UNITED STATES
NUCLEAR REGULATORY COMMISSION
WASHINGTON, D. C. 20555

SUBJECT: REVIEW OF GE TOPICAL REPORT, NEDM-20988, "CAORSO
RELIEF VALVE LOADS TESTS - TEST PLAN" (TAC-2285)

Request for Additional Information
General Electric Company
Topical Report: NEDM-20988, Revision 2
Test Plan - December, 1976
Reviewed by: T. M. Su

SUBJECT: SUMMARY OF MEETING HELD ON APRIL 4, 1979 WITH REPRESENTATIVES
OF THE GENERAL ELECTRIC COMPANY TO DISCUSS SRV METHODOLOGY

Figure 14 . Effect of Pipe Air Volume on Frequency for Initial Pipe and Wetwell Pressure of 3.7 psia

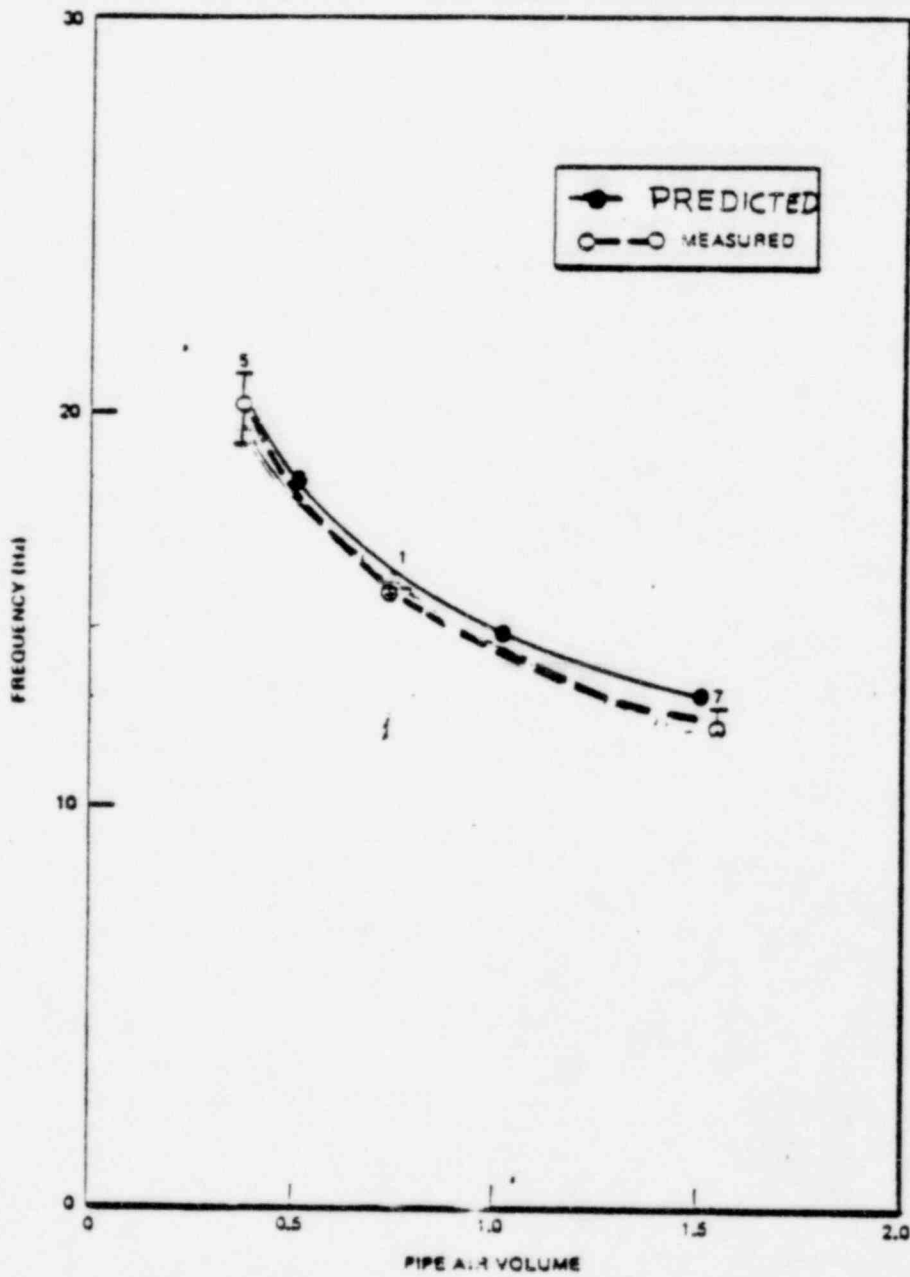
QUESTION 9: IT IS PROPOSED THAT THE QBF DISTRIBUTION BE SHIFTED TO ACCOUNT FOR SRV LINE VOLUMES THAT DIFFER FROM THE 50 FT³ LINES USED TO OBTAIN THE DATA. THE PROPOSED ADJUSTMENT IS BASED ON A SIMPLISTIC AND POSSIBLY NON-CONSERVATIVE ANALYSIS WHICH NEGLECTS THE KNOWN DEPENDENCE OF BUBBLE PRESSURE ON AIR LINE VOLUME. A REASSESSMENT OF THIS ASSUMPTION IS REQUIRED.

$$\text{FREQUENCY} \propto \sqrt[3]{\text{AIR VOLUME}}$$

THE ENTIRE RELATIONSHIP HAS BEEN EXPERIMENTALLY CONFIRMED IN 1/4-SCALE T-QUENCHER TESTS FOR LINE VOLUMES RANGING FROM 24 FT³ TO 99 FT³ (SEE FIGURE 14)
